CITY OF WEST LAKE HILLS, TEXAS
NOTICE OF BOARD OF ADJUSTMENT (BOA) REGULAR MEETING
Wednesday, February 11, 2026 at 7:00 PM

603 Spurlock Valley Rd.: Discuss and consider action on a recommendation from ZAPCO for a variance to install a new septic tank encroaching on the 30-foot front building setback (Section 22.03.276 and Section 22.03.281).

Re: Project Number 2025-12698
The Allday Residence
603 Spurlock Valley, West Lake Hills, Texas 78746
Lot 9, Block G, Stonehedge Estates

*Previous approved OSSF plan for 603 Spurlock.

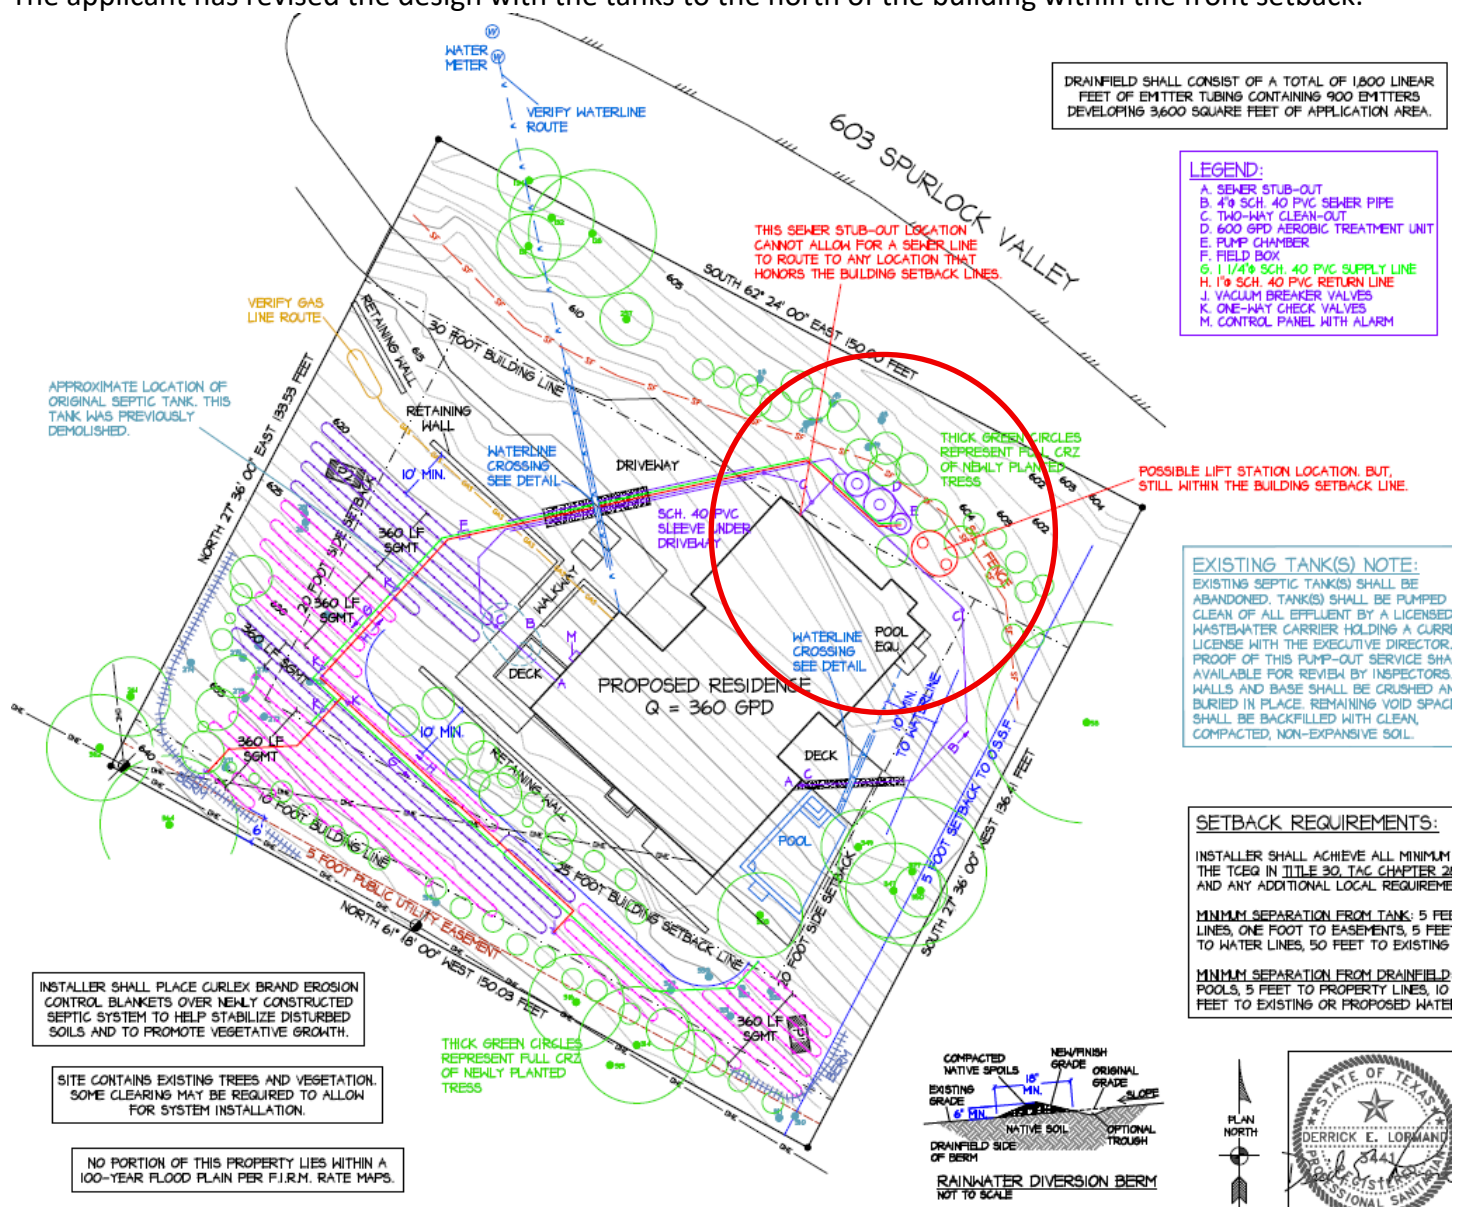
The property was built in 1985. The previous property owner received a permit for a remodel and addition in April 2023. The house was 1,888 sf of conditioned space and they are adding an additional 1,897 sf of additional conditioned space, with 4,959 sf of impervious cover on site. The site had an OSSF installed with tanks to the west of the building, outside of the setbacks. A previous OSSF design was approved in 2024 that proposed tanks in a similar location to the existing.

*Proposed OSSF Plan from Applicant

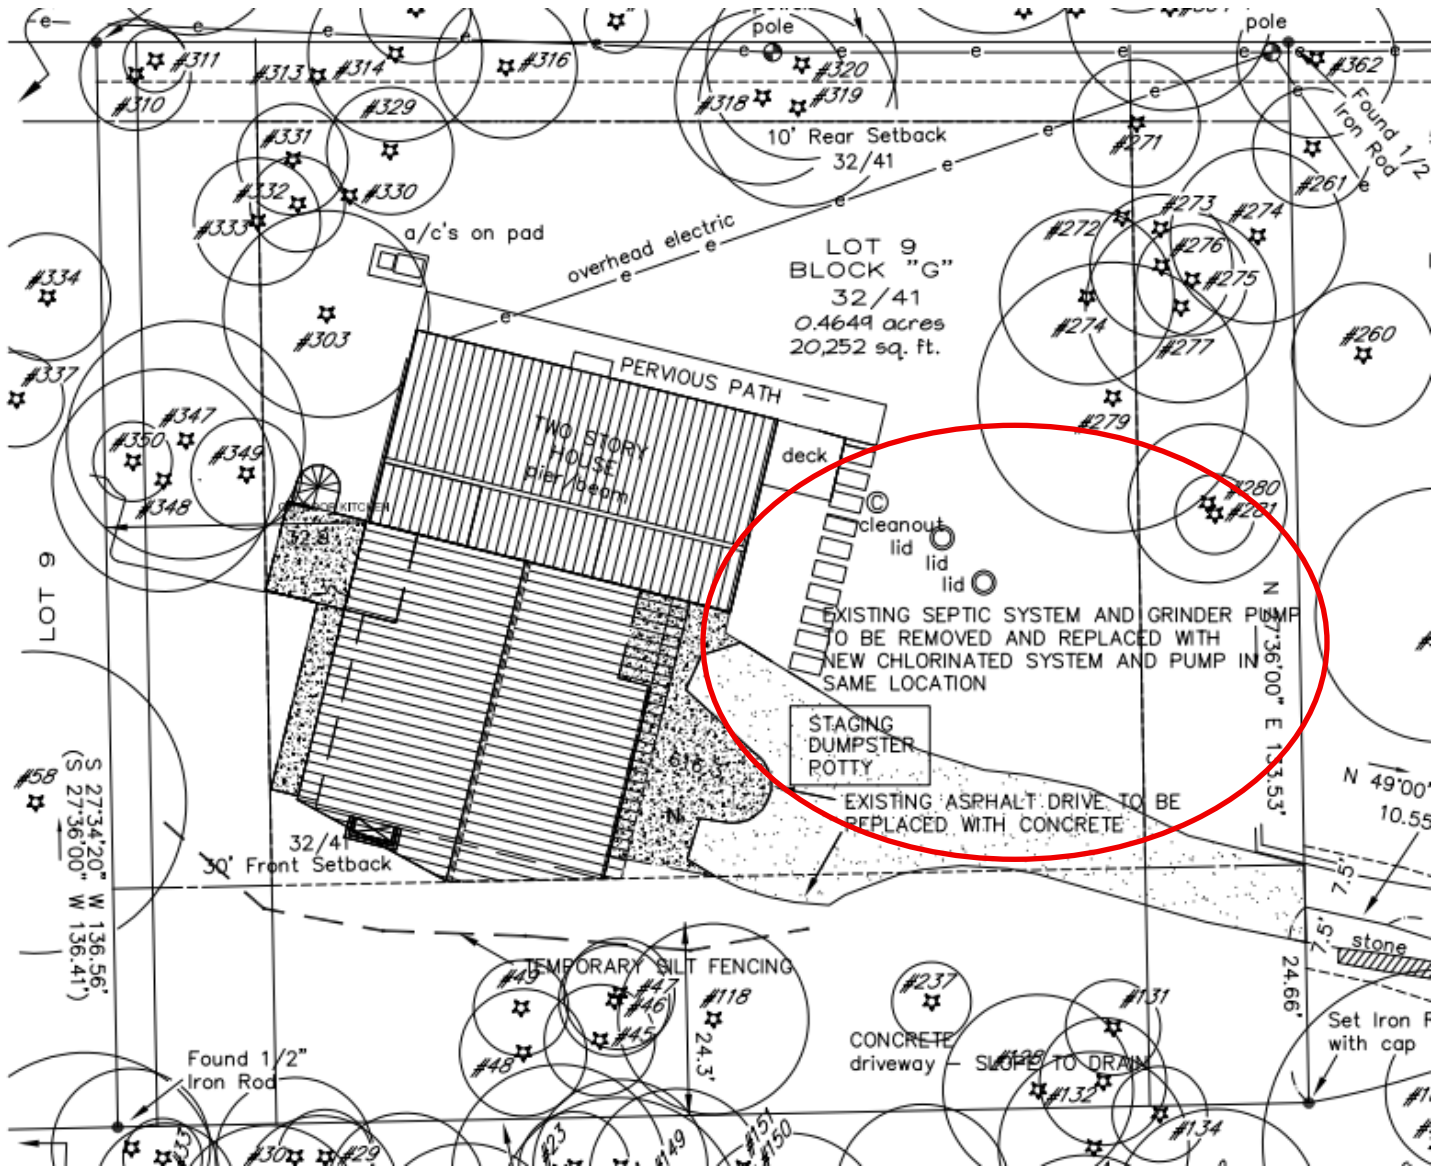
The applicant has revised the design with the tanks to the north of the building within the front setback.

The applicant states that the sewer stub out in that location was approved on the building plans, but staff has not found a reference to the location the approved plans. The approved plans had a note that the OSSF would be replaced in a same location as the existing system.

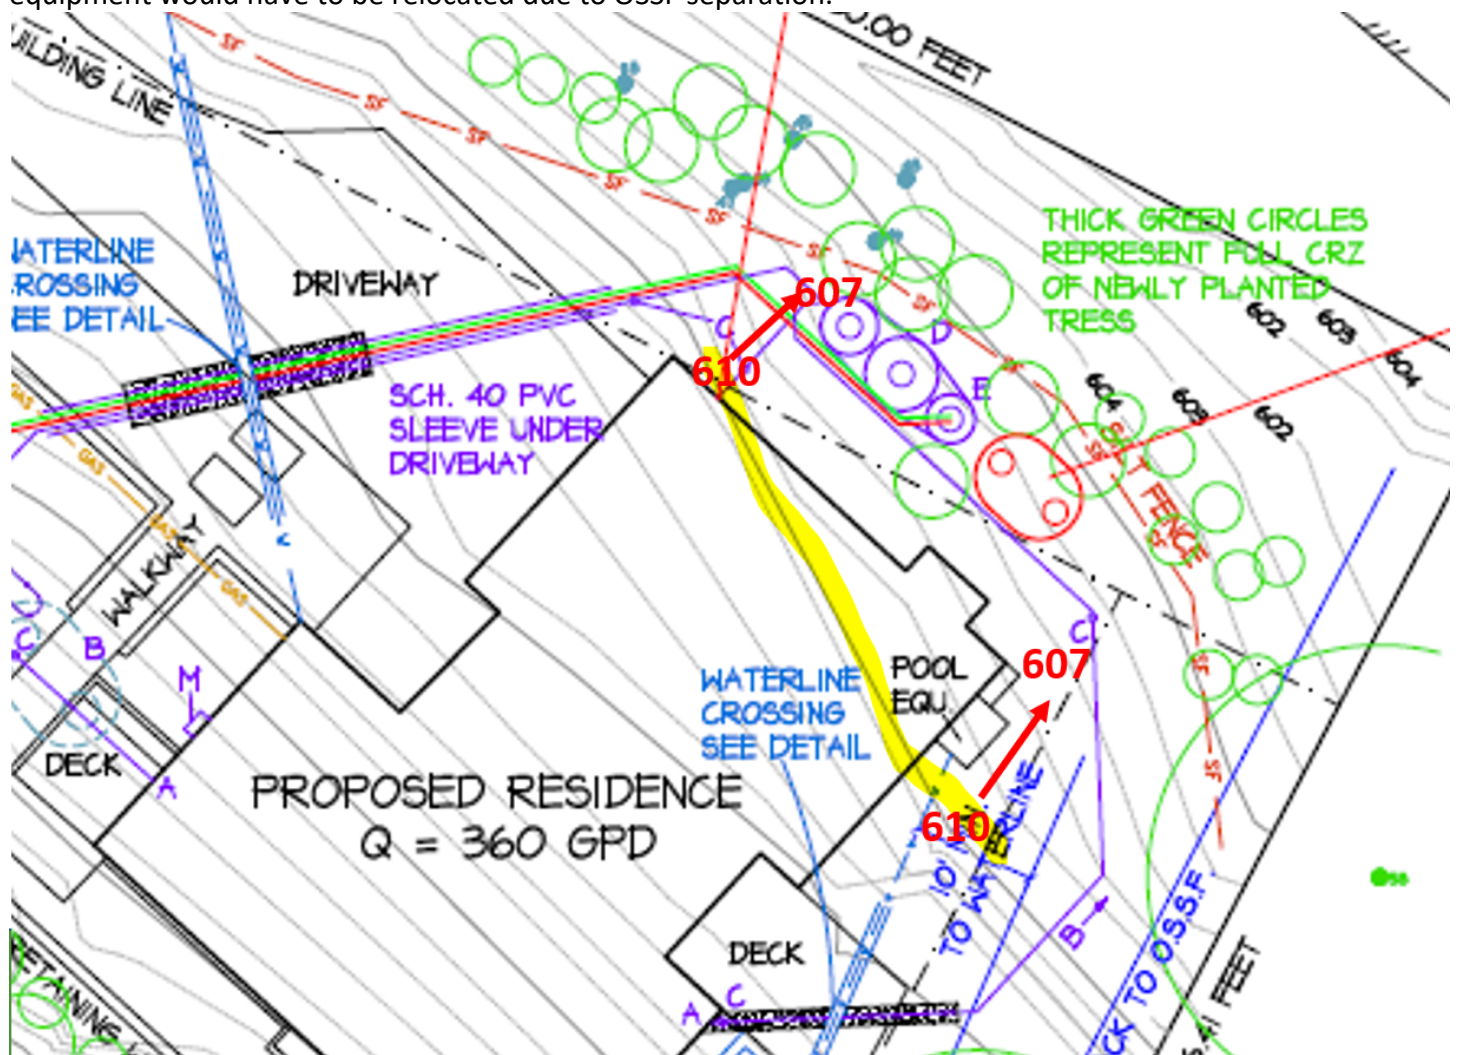
Staff cannot design the site but if the elevation is a driving factor, there are similar elevations on the east side of the house (610 elevation at the house to 607 at the tanks) that would be further from the creek. The pool equipment would have to be relocated due to OSSF separation.

REVISED SHEET I - SITE PLAN

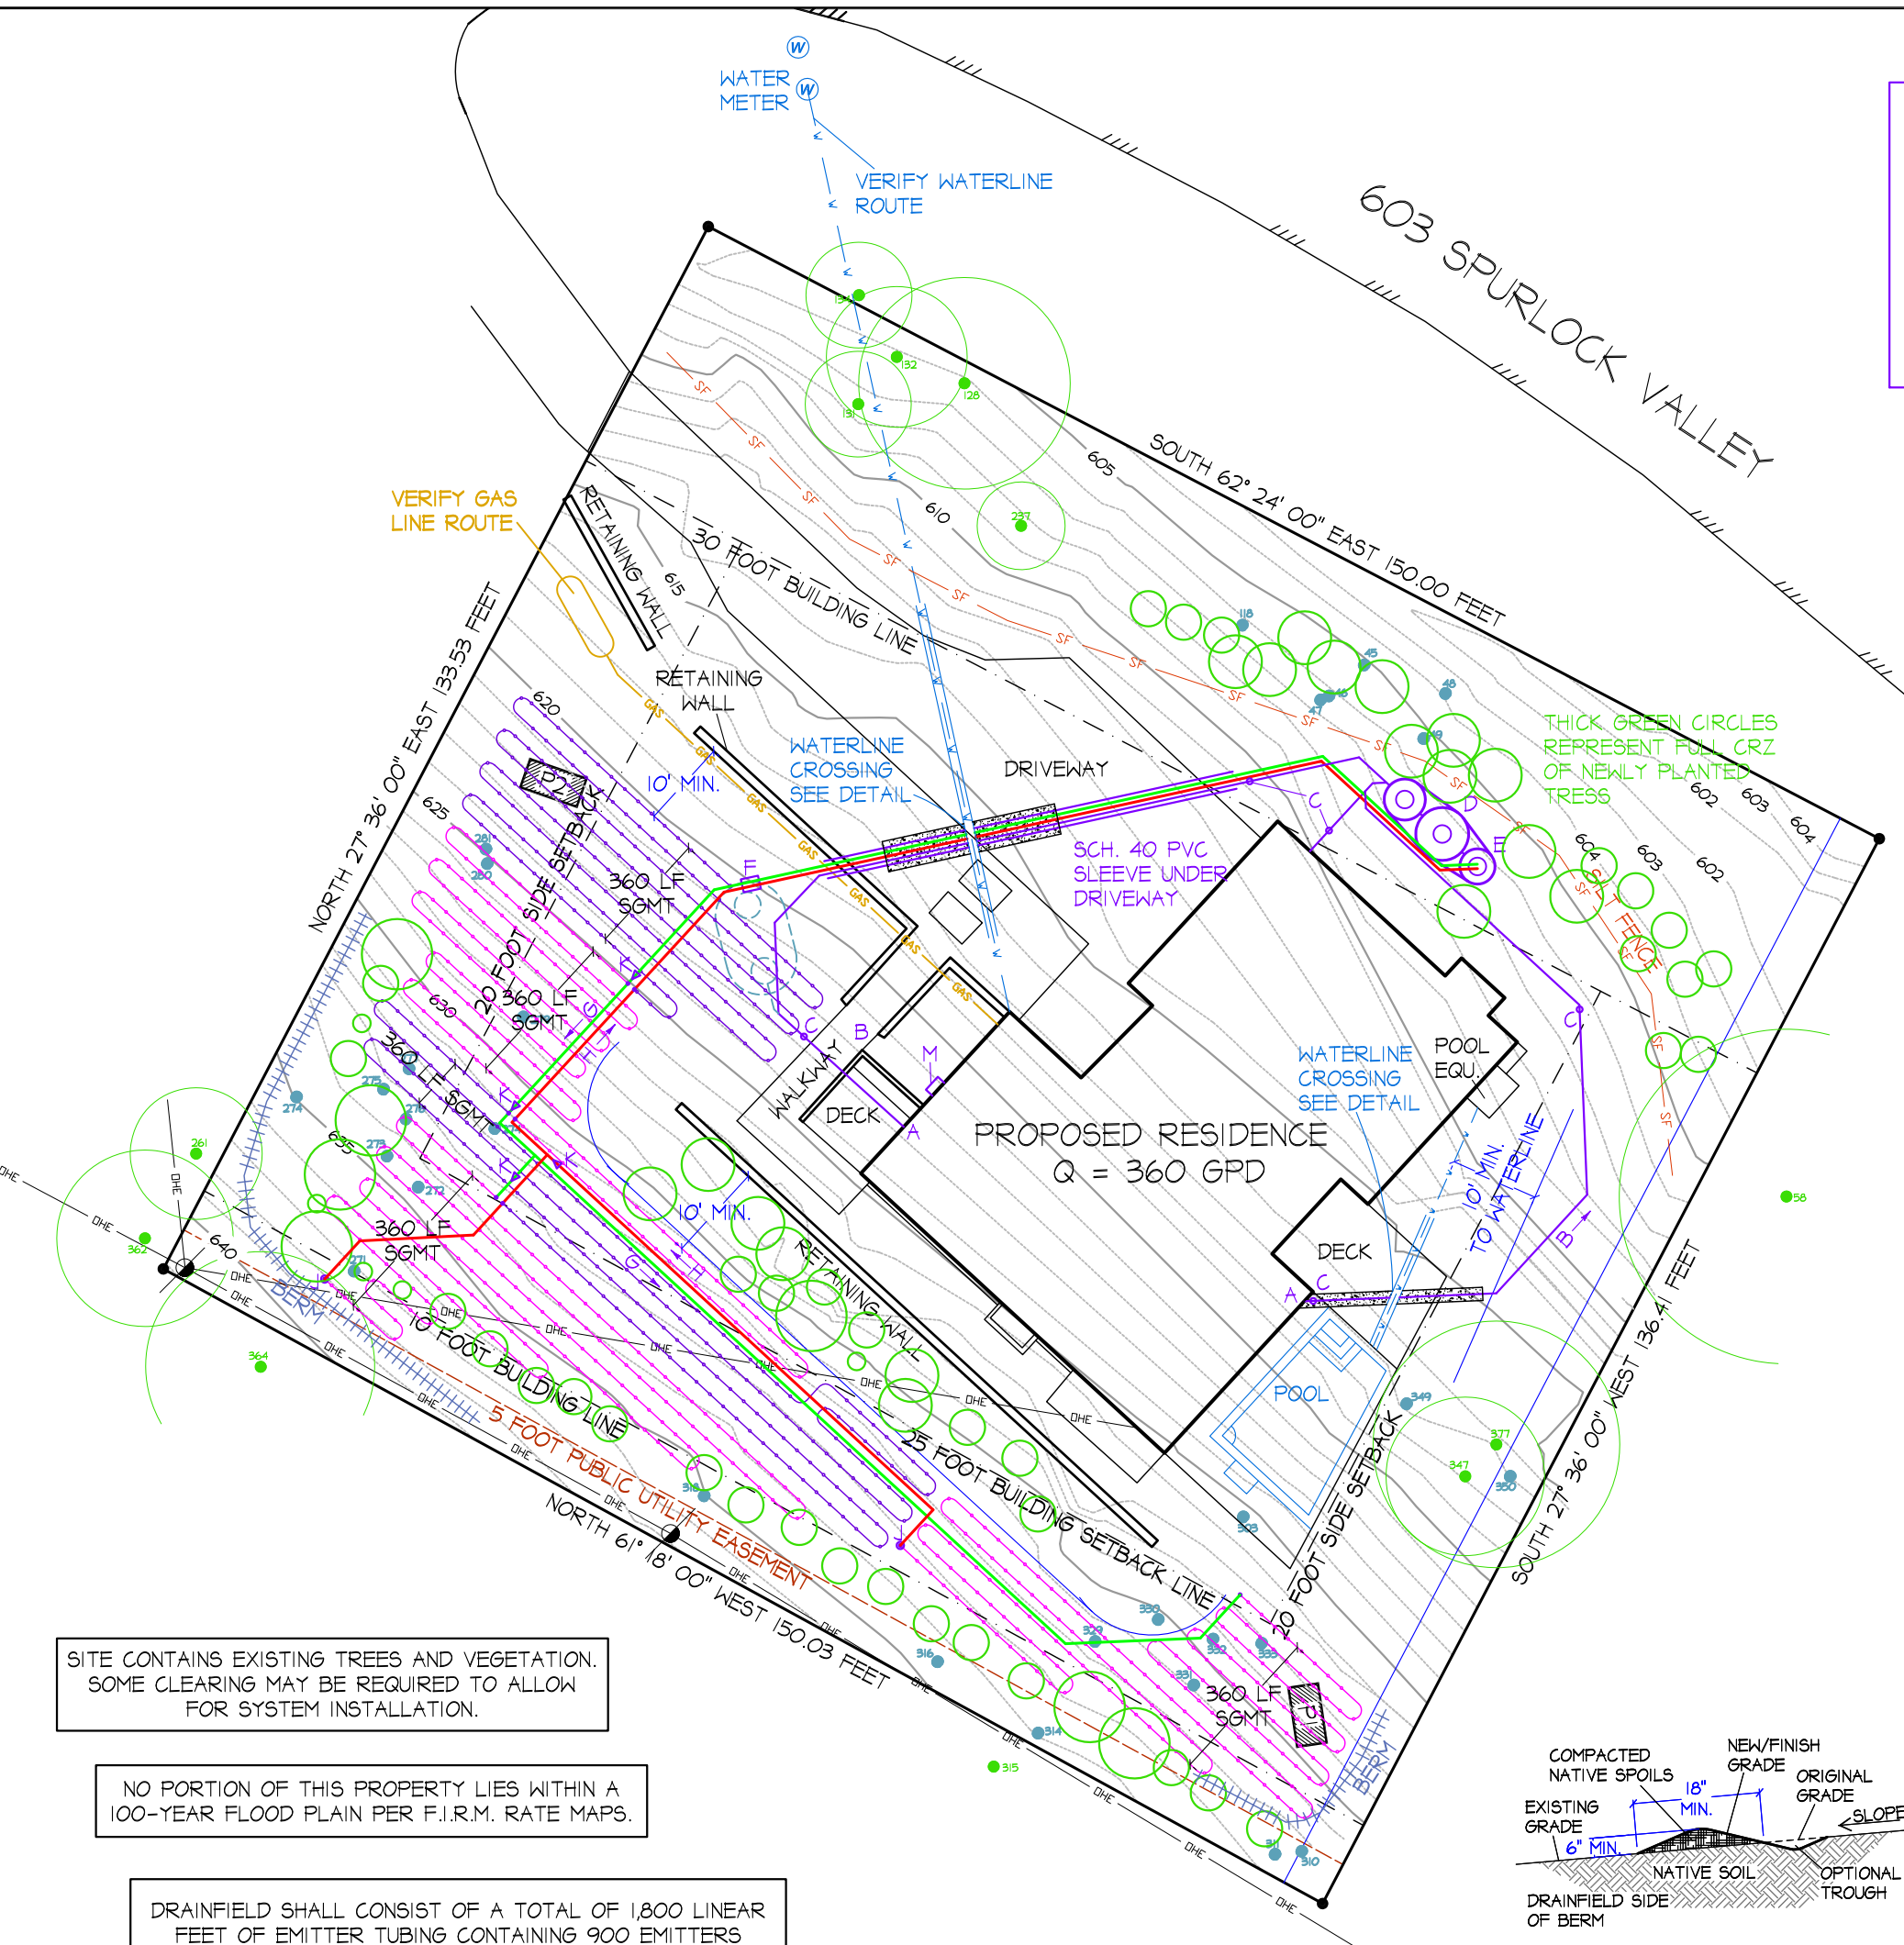
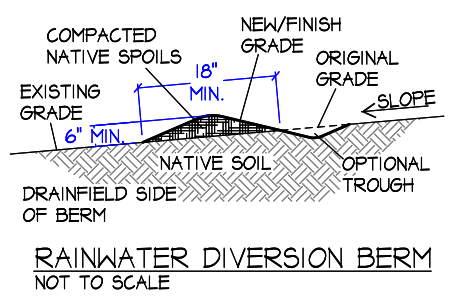
1. The proposed septic treatment tank must be positioned within the building setback lines as there is no other location available to place a tank and collect the wastewater from each of the three existing sewer lines exiting the foundation. The proposed location for the tank is, in my opinion, the most logical location and allows for all three lines to route by gravity. Installing this treatment tank at any alternate location would then require the use of one or more lift station tanks - which would also be placed within the building setback lines.

For the stated reason, I must request a variance from the minimum standards to allow for the installation of the proposed treatment tank within the 30-foot building setback line. The building line setback applies to the proposed septic treatment tank per Section 22.06.276 "Setbacks for Accessory Structures" per the City's code. The proposed tank location will still provide approximately 19 feet of clearance to the front property line while still honoring the 5-feet of clearance to the residence's foundation, and the tanks will be somewhat hidden with the proposed landscaping. It is my professional opinion that equivalent protect to both the environment, and the public health will be maintained even with the approval of this request. The proposed treatment tank location and the balance of the full system design honor all other code requirements required by Title 30, TAC Chapter 285.

REVISED SHEET I - SITE PLAN

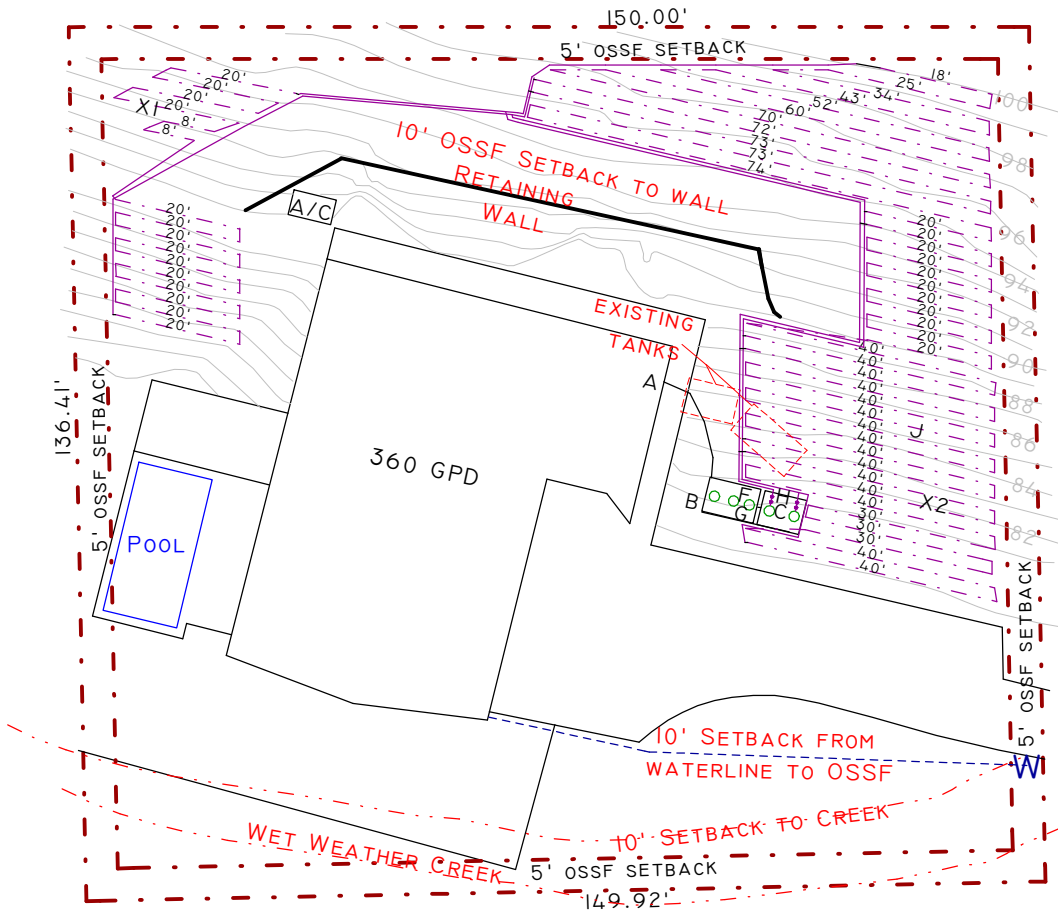
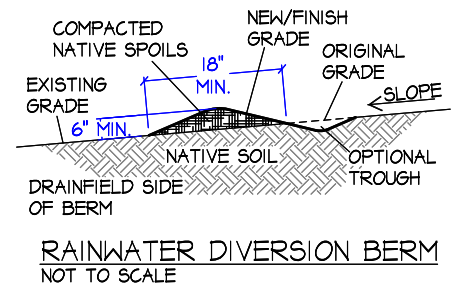
Comments: A plan was approved that has the stubout in the easement. Due to it being in the lowest elevation, there is no other option. It is also below grade, not a vertical build and therefore will not be seen.
